McLaren 720S – WCAC Hose to CCV Pipe Clash Rework

Bulletin type: Service Campaign Bulletin
Reference number: SCB14 L 001
Campaign reference: 04U
Attention: Retailer Service Managers and Retailer Technicians
Affected vehicles: 720S; Coupe and Spider
Situation: Potential for Insufficient gap tolerance between components
Procedure: To action affected vehicles during next Retailer visit.
Please refer to the information outlined in this document to ensure sufficient gap tolerance is created between mentioned components
Date: 5th September 2019

Layout overview - CCV pipe (2), WCAC hose (3)

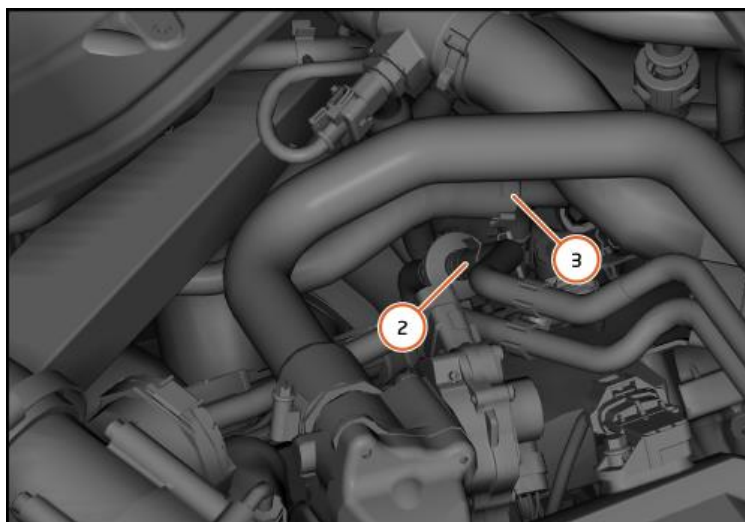
McLaren Automotive has identified through continuous product quality monitoring, that a number of McLaren 720S vehicles (Coupe and Spider versions) may have an insufficient gap tolerance between the Water Charge Air Cooler (WCAC) hose and Crankcase ventilation pipe (CCV). This could cause a clash condition and subsequent damage to the components.

To carry out the required re-work, installation of a double 'C' clip is required which will increase the gap tolerance and prevent further potential clashes.
